SITE: Town Farm Poultry Unit, Town Farm Road, Castle Frome, Ledbury, Herefordshire HR8 1HQ

DESCRIPTION: Erection of 2 No. additional poultry buildings and associated infrastructure on established poultry farm

APPLICATION NO: 172144

DATE OF THIS RESPONSE: 15th August 2017

Figure 1: Environment Agency Flood Map for Planning (Rivers and Sea), August 2017

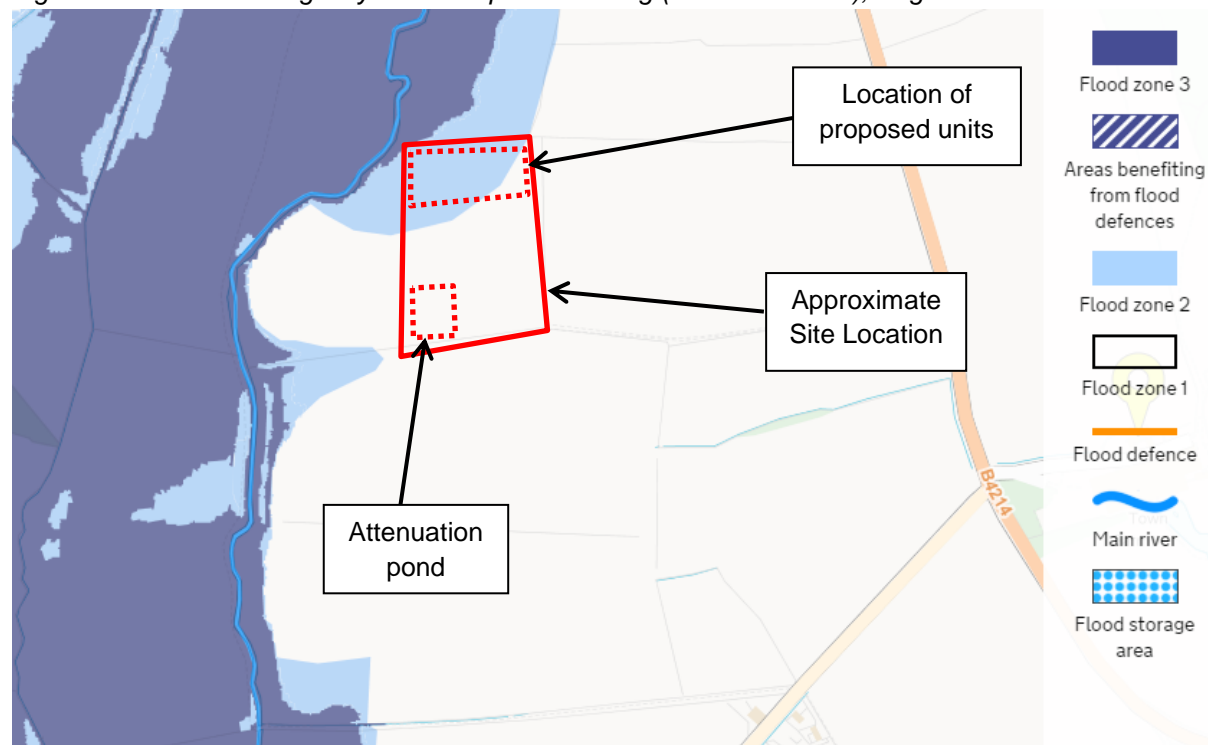
Review of the Environment Agency's Flood Map for Planning (Figure 1) indicates that the proposed poultry buildings are located within the medium risk Flood Zone 2 and partly within the low risk Flood Zone 1. Flood Zone 1 comprises land assessed as having less than a 1 in 1,000 annual probability of river flooding. Flood Zone 2 comprises land where the annual probability of flooding from fluvial sources is between 1% and 0.1% (between 1 in 100 and 1 in 1000).

This planning application has been supported by a Flood Risk Assessment (FRA) which states that the Environment Agency Flood Map is not accurate. We concur with this technical assumption. Based on the Environment Agency mapping, the extent of Flood Zone 3 extends to approx. 70.2m AOD. The proposed poultry buildings are at 71.2m AOD existing ground levels. The Applicant has not stated the finished floor levels of the proposed broiler units. The finished floor levels should demonstrate that risk of fluvial flooding has been mitigated. As there is around 1m of freeboard between the existing Flood Zone 3 extent and the proposed site, we consider that there is sufficient freeboard to cater for increased levels arising from 20% climate change.

The Applicant should refer the Applicant to Environment Agency Standing Advice for the requirements of their development in the identified flood zone. (<https://www.gov.uk/guidance/flood-risk-assessment-standing-advice>).
